**ATTN: Aquifer Exemption**

On behalf of the Natural Resources Defense Council (“NRDC”), which has 2.4 million members and activists, more than 380,000 of whom are Californians, we write to submit our comments on the proposal to expand the current aquifer exemption designation for the Dollie Sands of the Pismo Formation in the Arroyo Grande Oil Field located in unincorporated San Luis Obispo County, near the intersection of Ormonde Road and Price Canyon Road.

**Figure 1:** Site map showing the proposed aquifer exemption boundary (red line), the current aquifer exemption boundary (blue line), the non-compliant UIC wells, and compliant disposal and EOR wells.

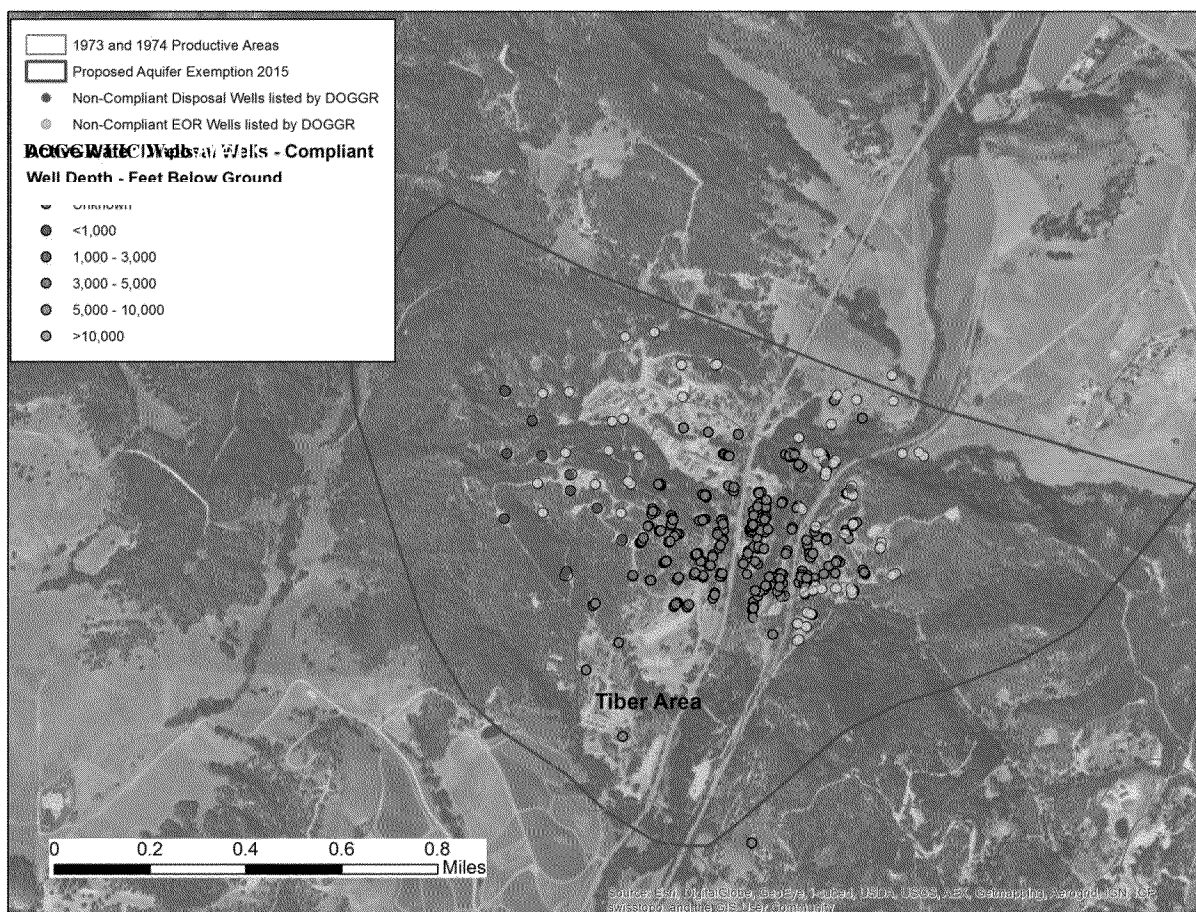
DOGGR and EPA have already exempted the hydrocarbon bearing zone, within the aquifer exemption boundary, as demonstrated in Figure 1. According to the ‘List of Permitted Wells Sent to EPA’<sup>10</sup> spreadsheet, 14 disposal wells (green dots) and 76 EOR wells (pink dots), all of them non-compliant, are located within the proposed aquifer exemption (“AE”) boundary (red line), yet outside of the currently exempted, hydrocarbon bearing aquifer boundary (blue line). The hydrocarbon bearing unit was based on a shapefile provided through DOGGR’s FTP website, which delineated the spatial boundaries for the 1973 and 1974 oil productive units. However none of the active UIC wells located within the exempted, hydrocarbon bearing aquifer were listed in the ‘List of Permitted Wells Sent to EPA’ spreadsheet suggesting they are in-compliance with SDWA.

EPA must not grant an aquifer exemption for disposal wells based on 40 CFR §146.4(b)(1), for a non-producing portion of the aquifer that is also not demonstrated to be suitable for economical hydrocarbon recovery. While the applicant claims, “Hydrocarbons are distributed throughout the oilfield reservoir, both vertically and aerially” (page 3) the location, distribution, and recovery of the economically producible hydrocarbons are overwhelmingly located within the already exempted portion (blue line) of the proposed aquifer exemption (red line). Currently, the zone outside the boundary of the existing exemption is host mostly to disposal wells.
